**ADDITIONS AND RENOVATIONS TO CAMPUS  
CONNECTICUT JUVENILE TRAINING SCHOOL  
MIDDLETOWN, CONNECTICUT  
PROJECT: BI-YS-170**

<b>BID OPENING</b>	<b>1:00 P.M.</b>	<b>JANUARY 11, 2012</b>
<b>ADDENDUM NUMBER TWO</b>	<b>DATE OF ADDENDUM</b>	<b>DECEMBER 30, 2011</b>

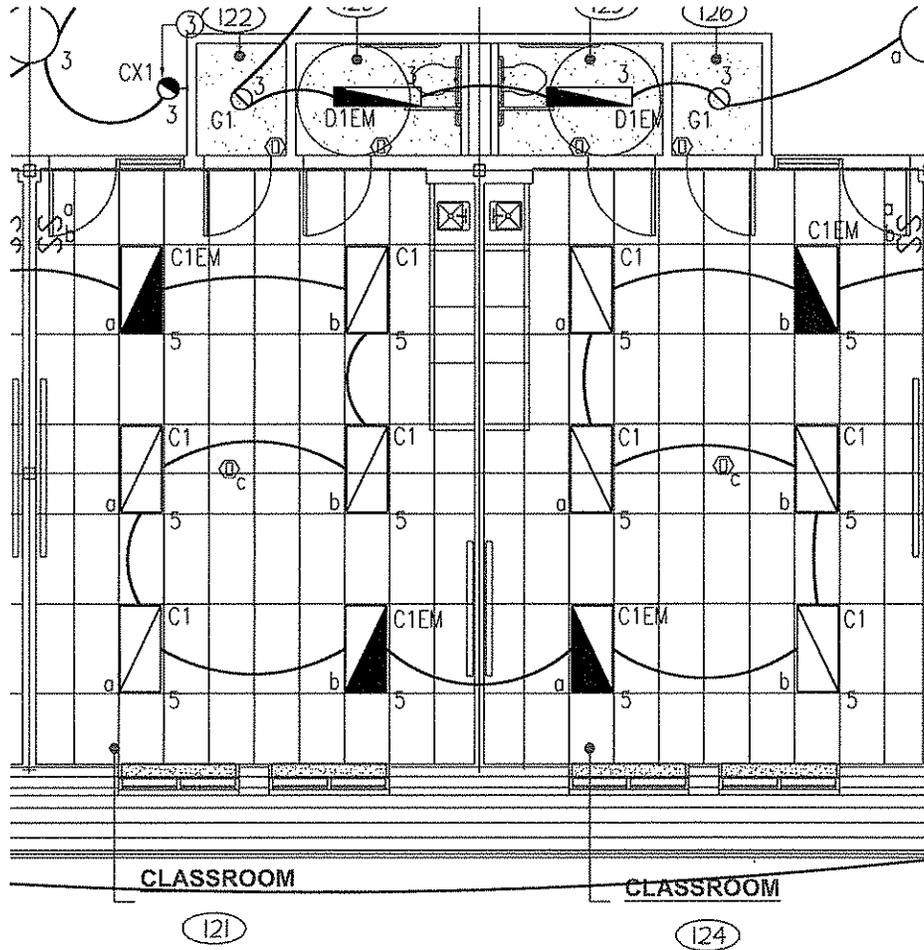
REVISE Drawing No. E701 - Electrical Lighting Plan as indicated on Sketches No. SK-E701-1, SK-E701-2, and SK-E701-3 (copies attached) dated 12/30/11.

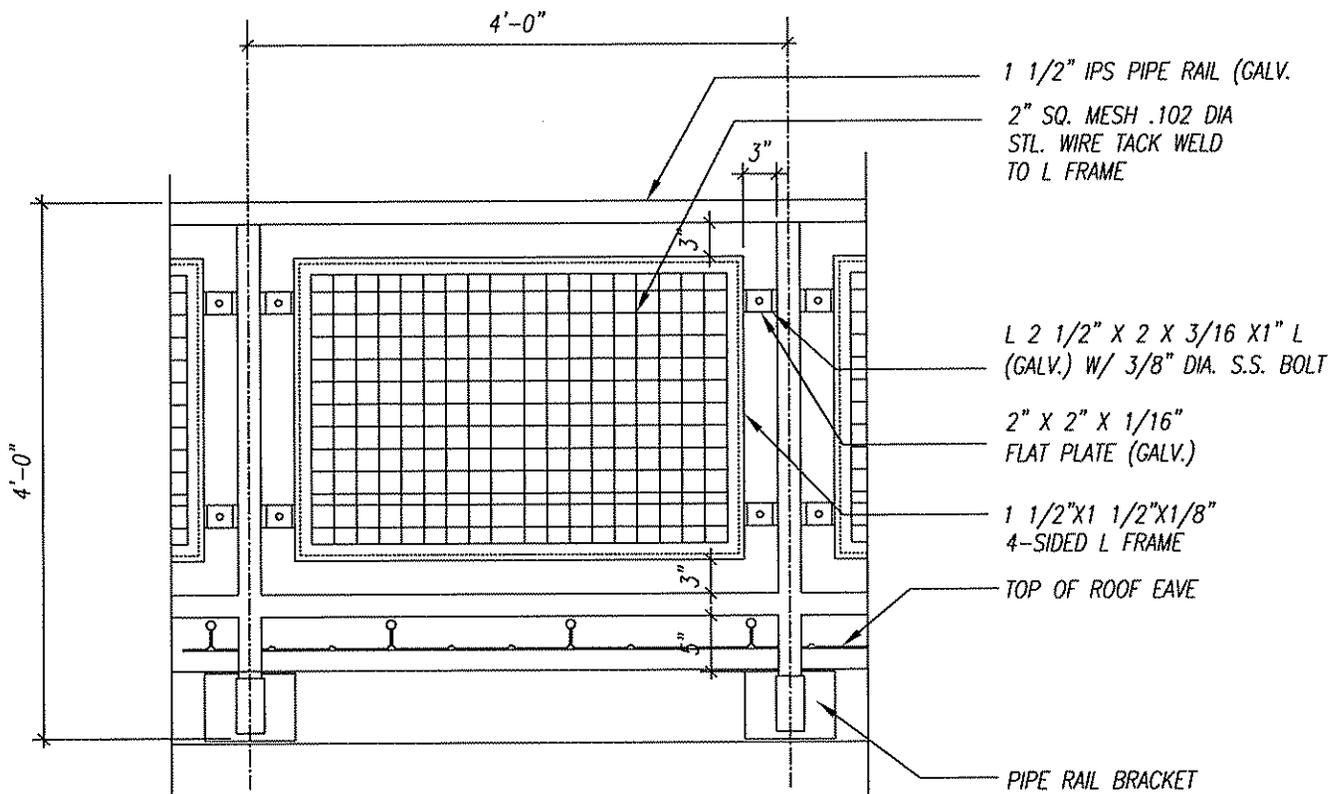
B. **Confirmed.**
6. Q. *Section 2/A301: Please provide more detail for the rail at the edge of the roof.*
  1. *Is there a spec for the "security mesh" for the rail at the edge of the roof?*

2. *What type of frame surrounds the mesh?*
  3. *How is the frame attached to the pipe rail?*
  4. *Detail A/A301 noted at the 3/8" steel plate bracket connection does not seem to be the correct detail. Please provide correct detail and reference. We assume this is bolted to structural steel and not the cold formed metal framing.*A. **Refer to attached Sketch SK-A301 dated 12/28/11. Steel plate bracket connection Detail A/A301 supports the roof security fence and is anchored through the wood fascia blocking into the structural steel bent plate with (4) 3/8" diameter bolts with nuts and washers.**

41. Q. *For the security guard rail at the roof, please clarify what size and type of mesh is required.*
- A. **Refer to Addendum No. 2 Sketch No. SK-A301.**

**B** DETAIL OF WIRE MESH PANEL CONNECTOR TO PIPE  
3" = 1'-0"

**A** ELEVATION  
3/4" = 1'-0"

NOTE:  
REFER TO WALL SECTION 2/A301  
FOR ADDITIONAL INFORMATION.
